FORESTSIDE TOWNHOUSES

TENDER ADDENDUM # 3

Date: January 31st, 2020

JAP Project No: 19066

Job No: 19066 Sheet No: S-101A

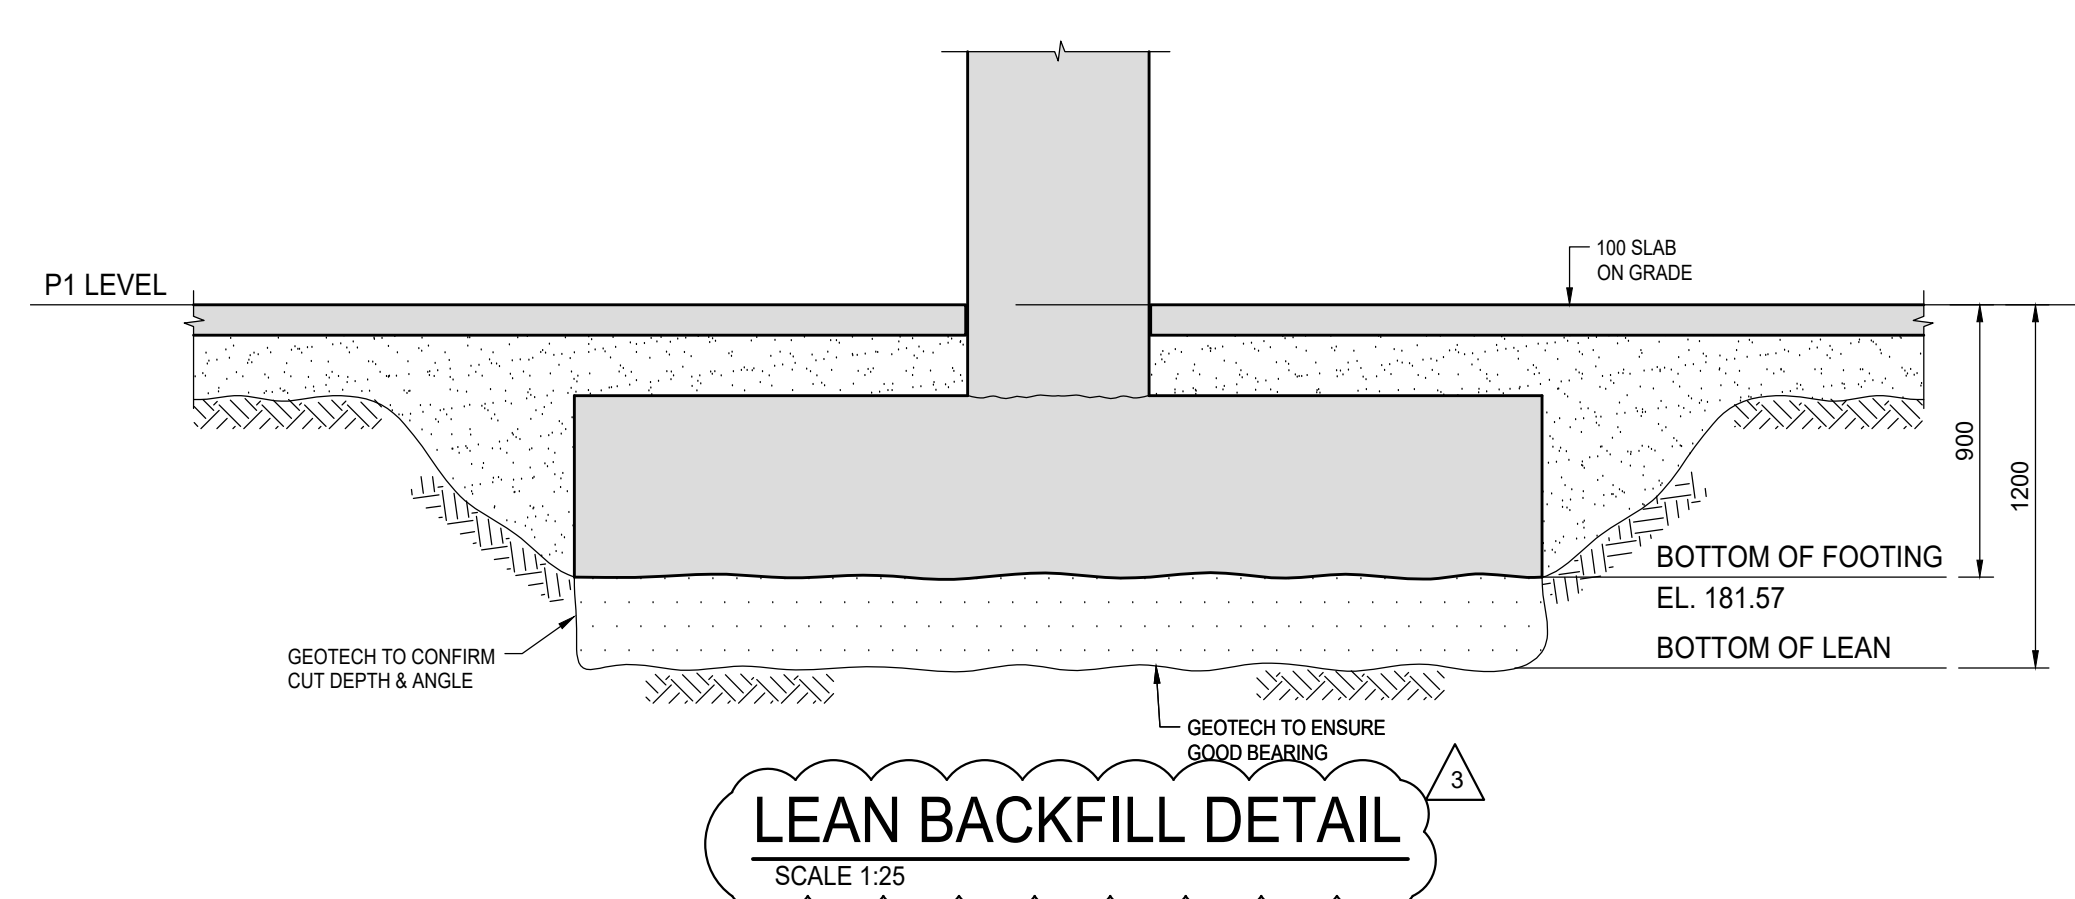
1.1 **Refer to Drawing S-101A & B "P1 UNDERGROUND"**

- a) Several concrete walls removed to be replaced by block walls.
- b) Mechanical openings added in walls to North West.
- c) Walls thickened at gridlines 19-R and 22-Q.
- d) All elevations changed to 181.57.

DETAIL A
SCALE 1:20
S-102A

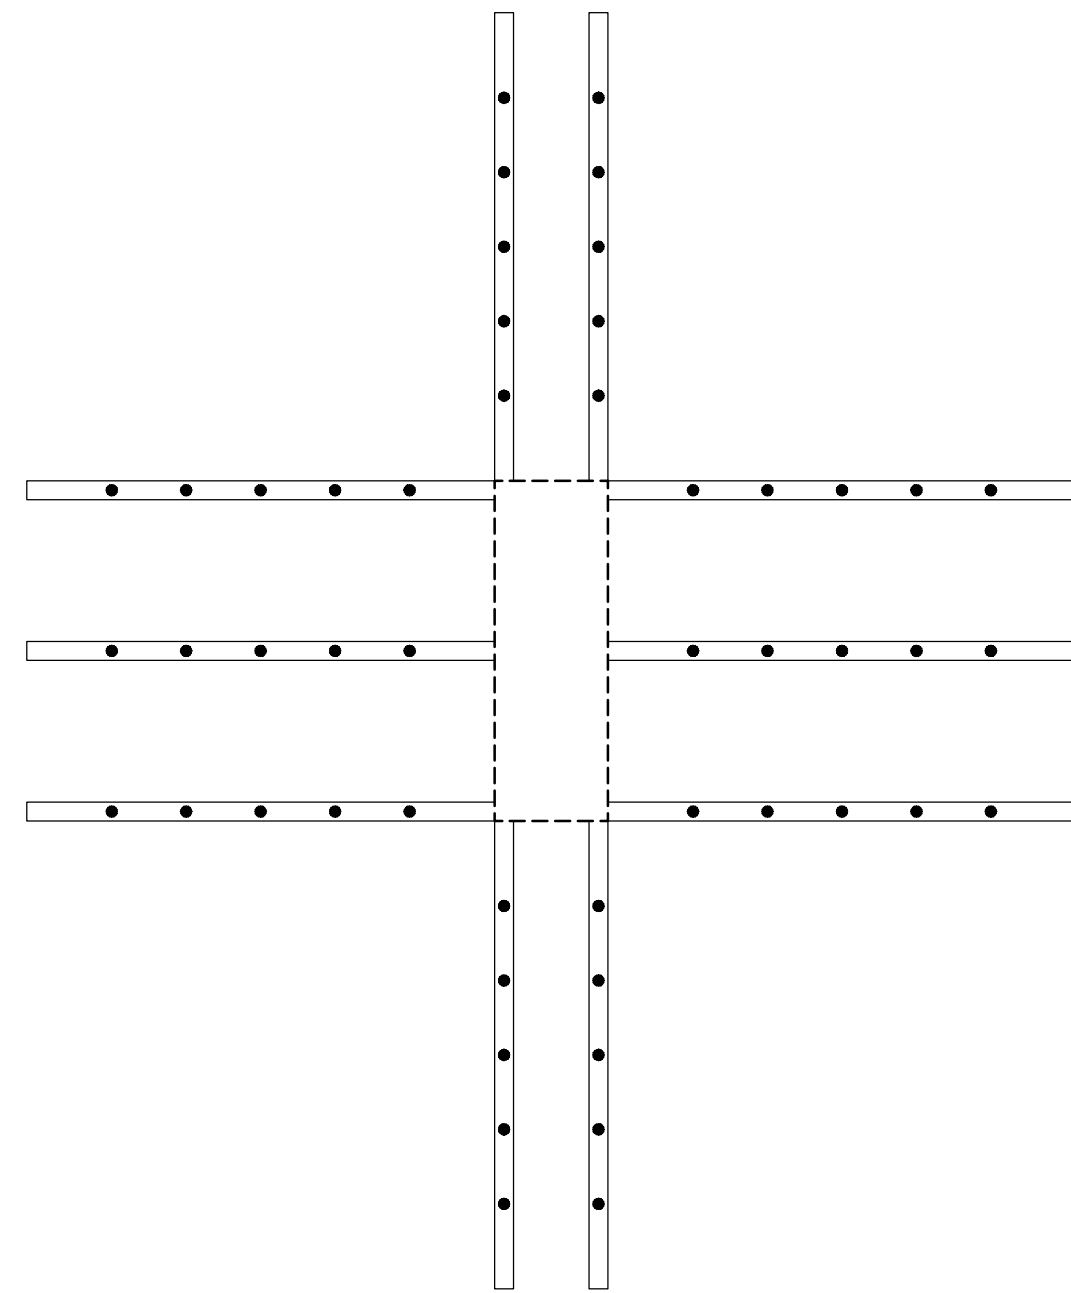
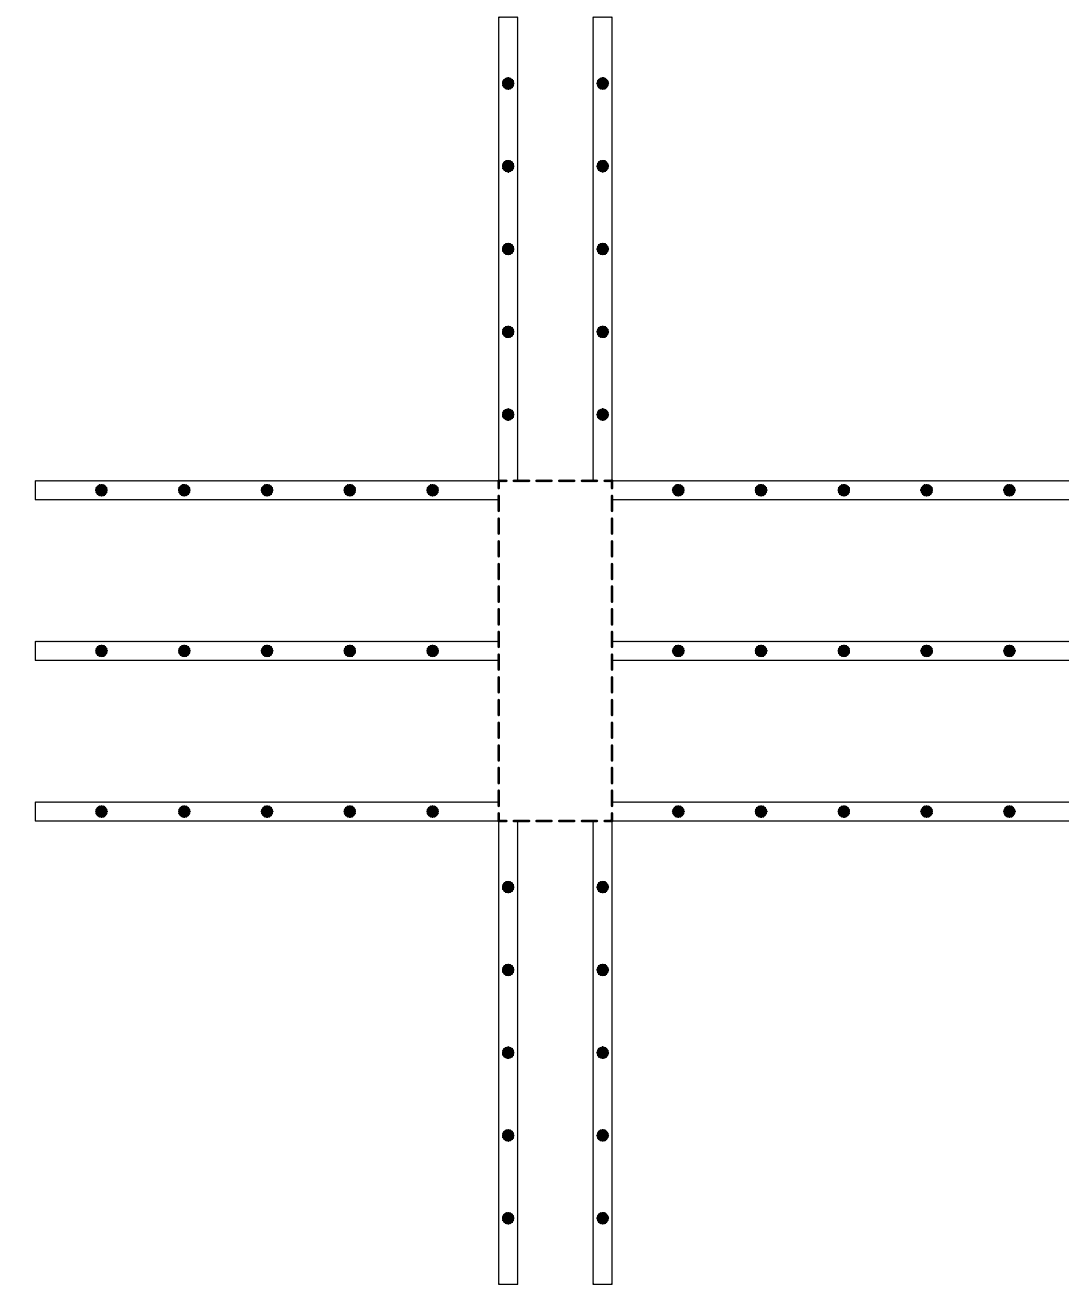
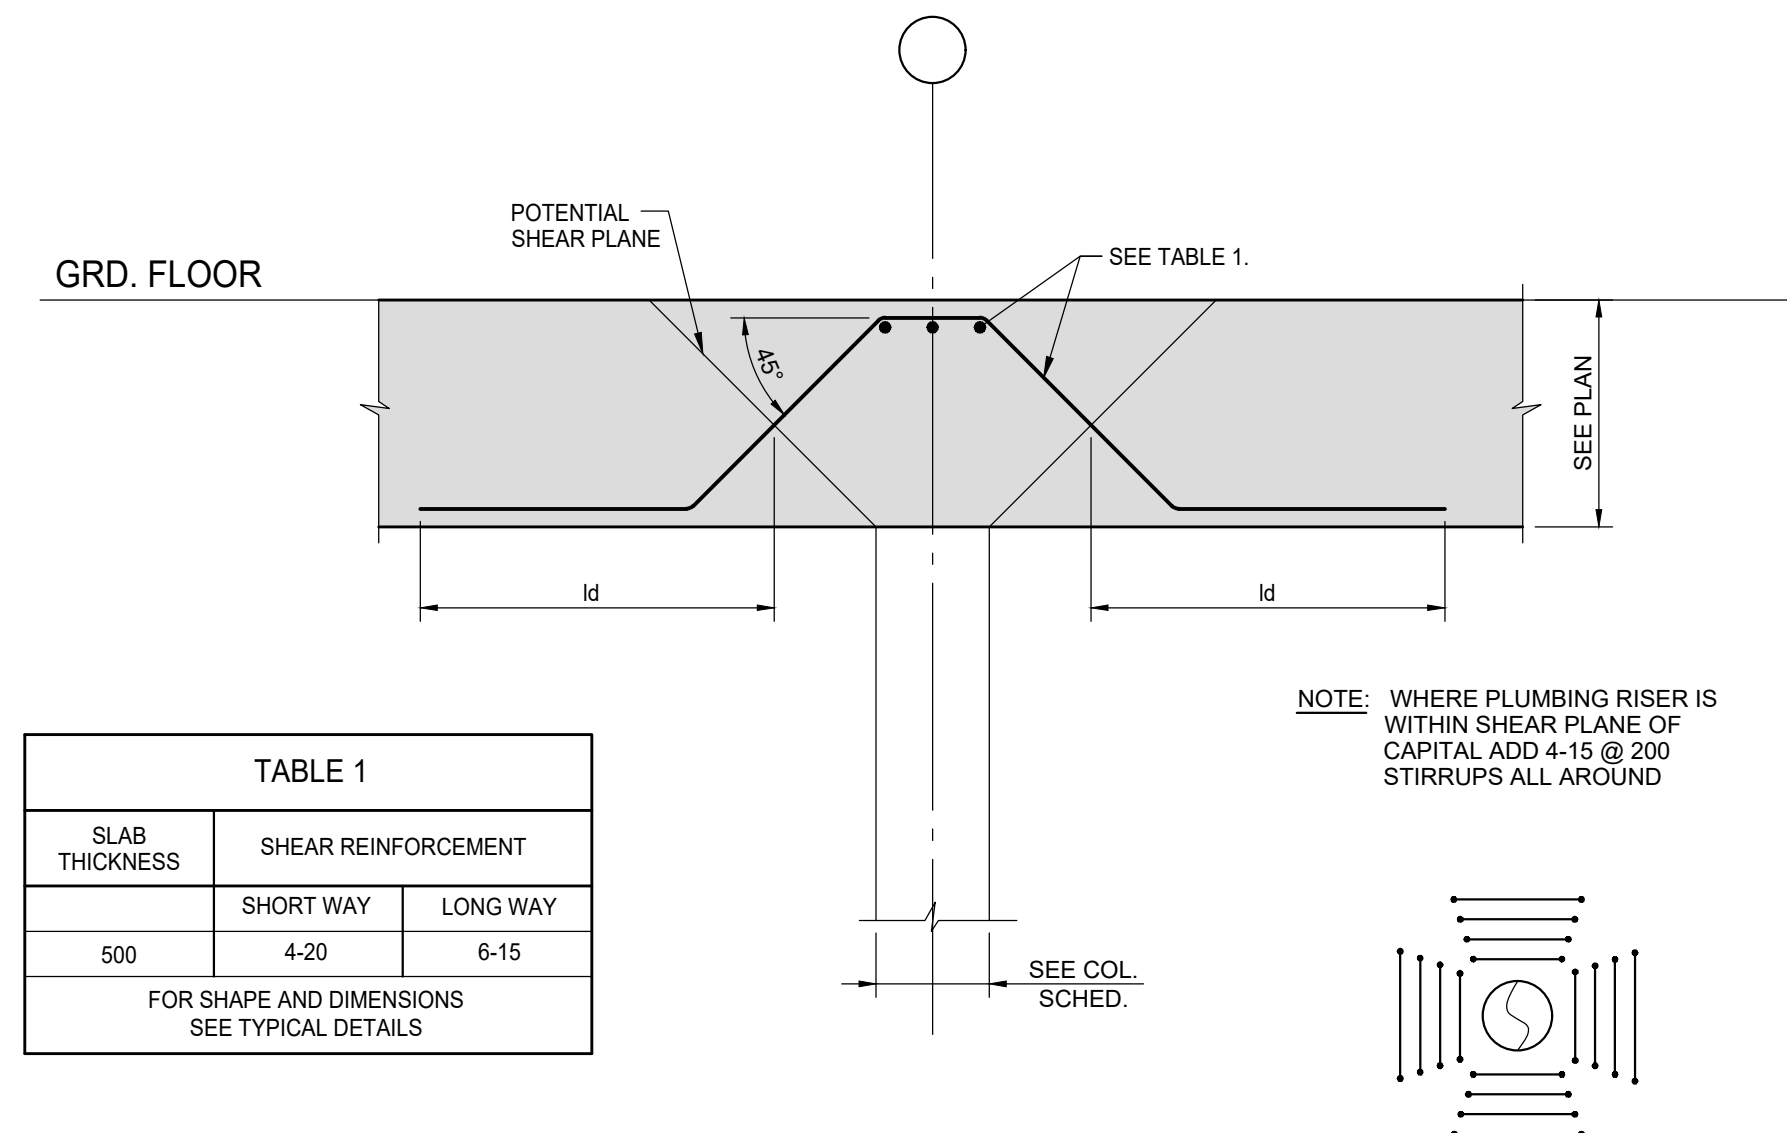
- e) Stud rail details 1 & 2 S-102A added to replace column capitals.
- f) Structure (column and walls) altered at client request.

PROVIDE 10 RAILS (1238x25.4x4.8mm)
c/w. 5-16mmØx445mm LG. STUDS @197mm c/c.
FIRST STUD AT 225mm FROM FACE OF COLUMN.

PROVIDE 10 RAILS (1238x25.4x4.8mm)
c/w. 5-16mmØx343mm LG. STUDS @219mm c/c.
FIRST STUD AT 175mm FROM FACE OF COLUMN.

Job No: 19066 Sheet No: S-102A

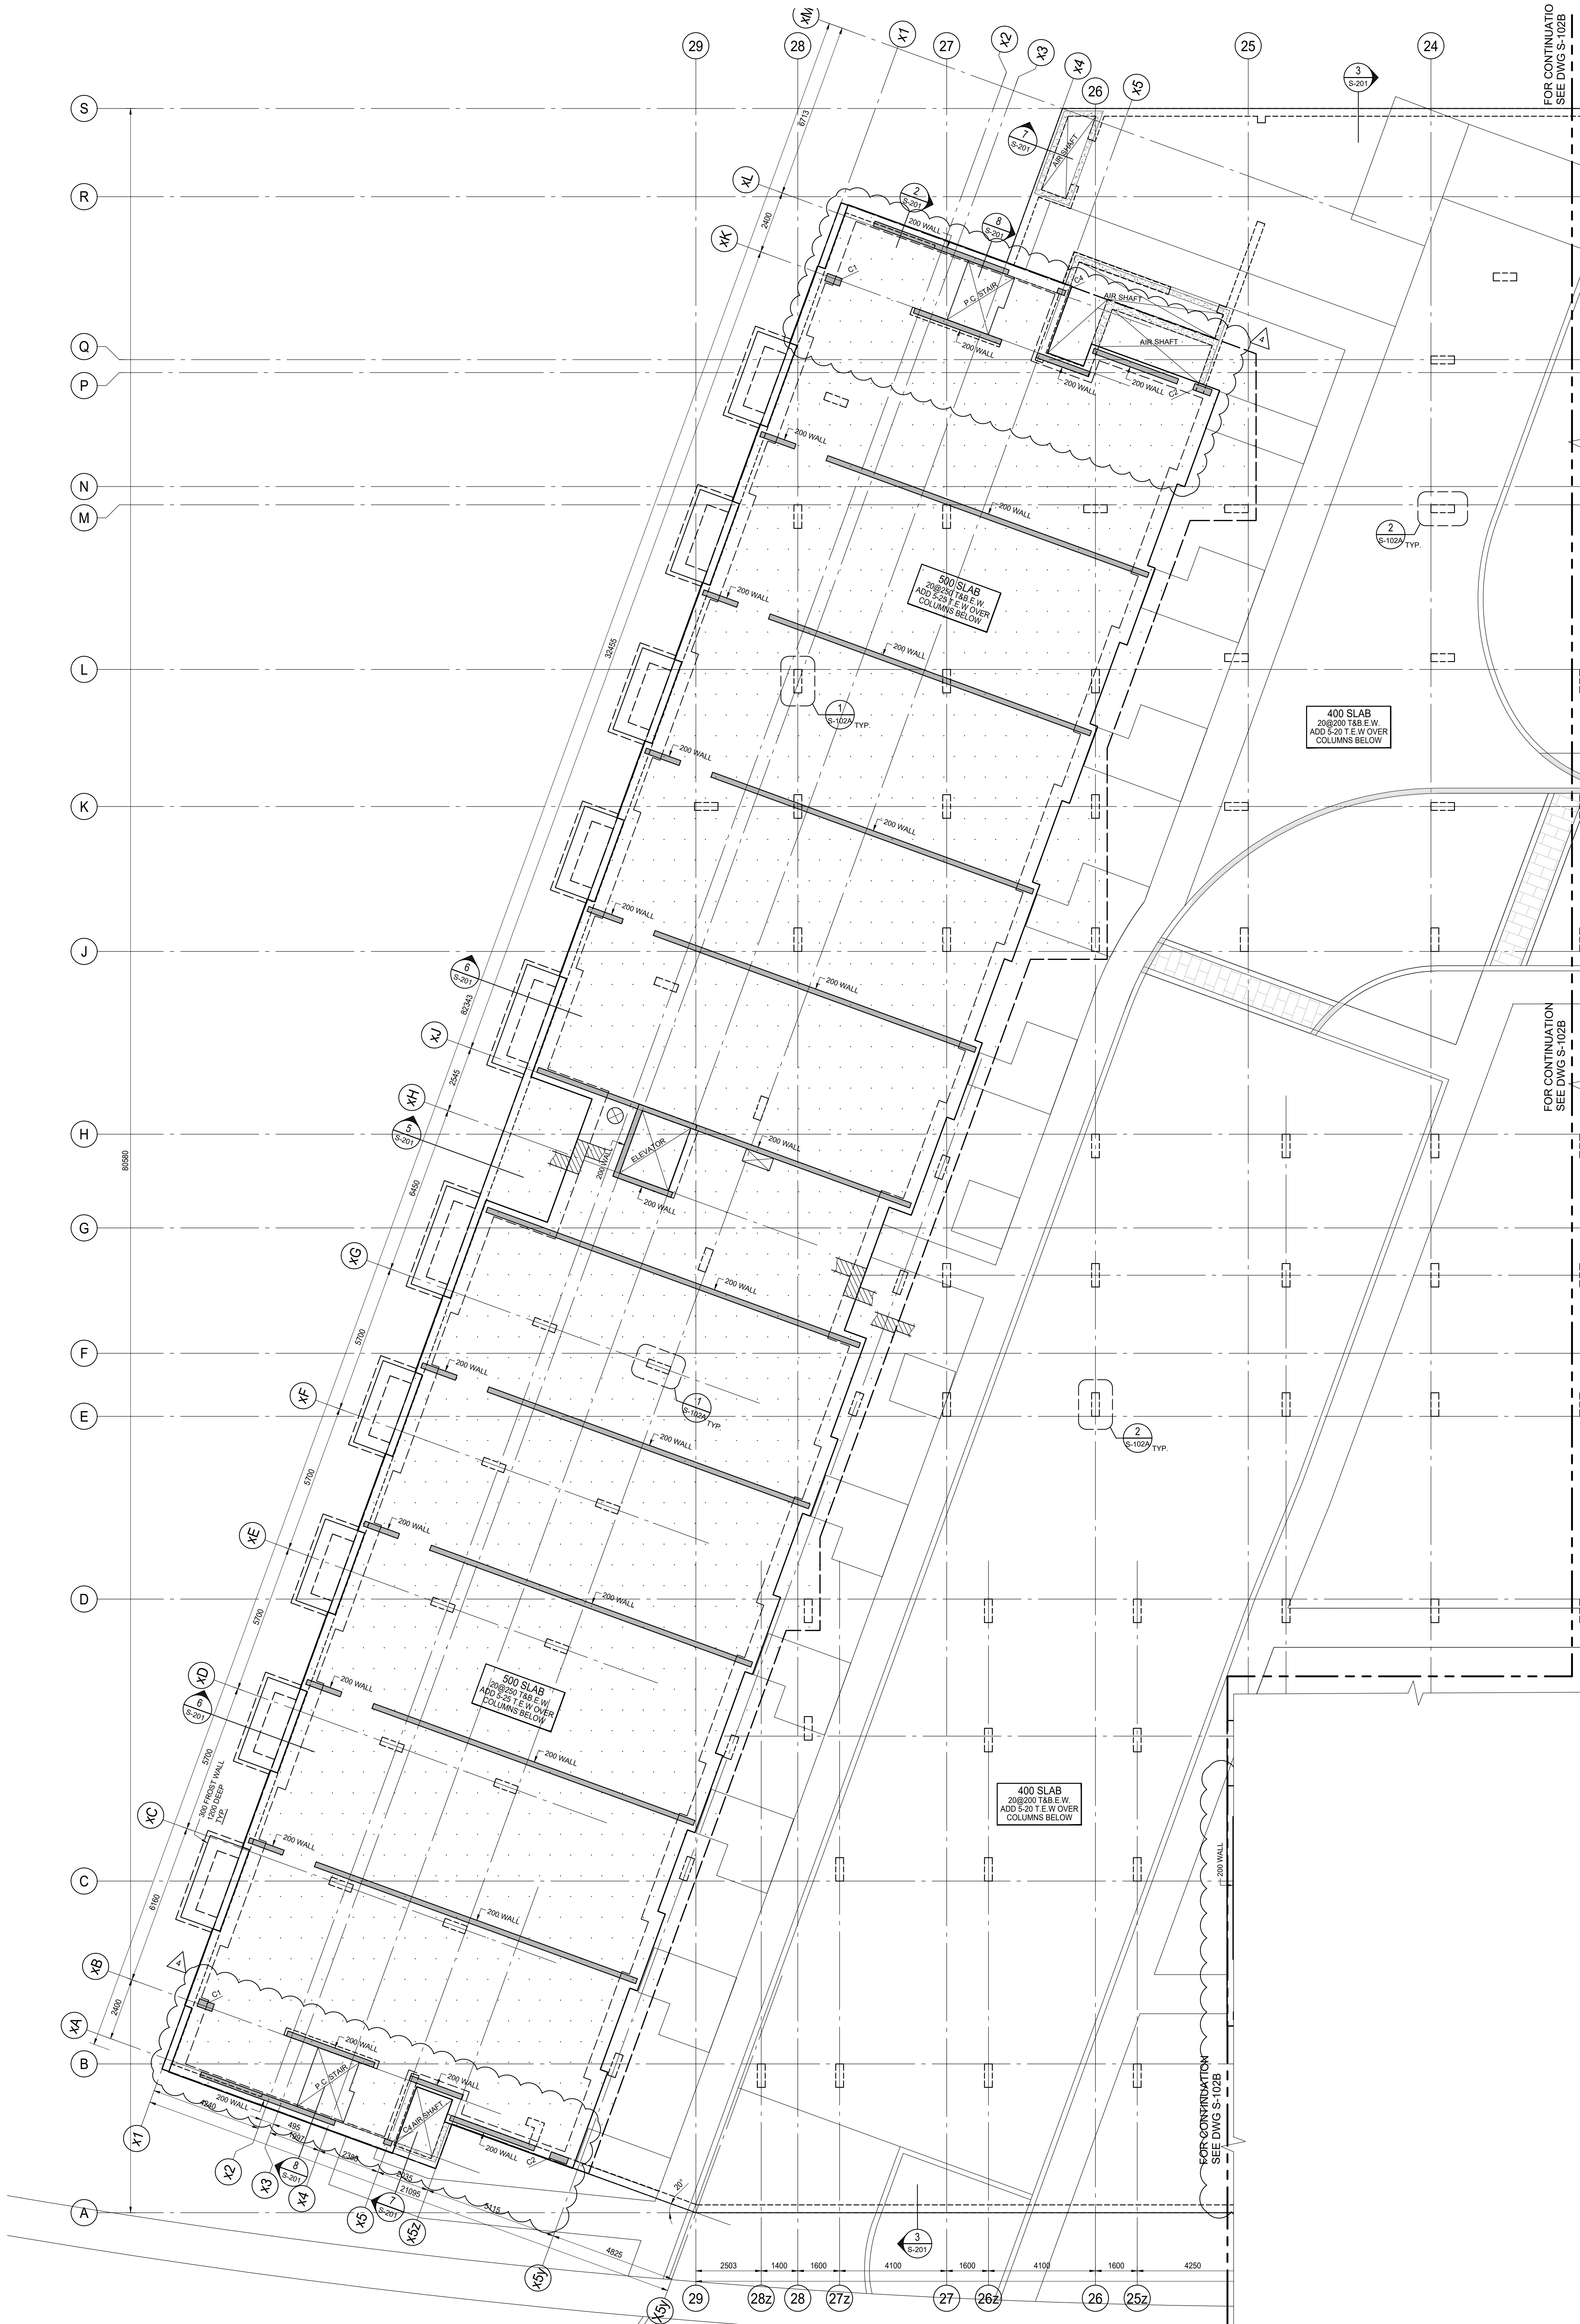
1.2 **Refer to Drawing S-102A & B "GROUND FLOOR"**
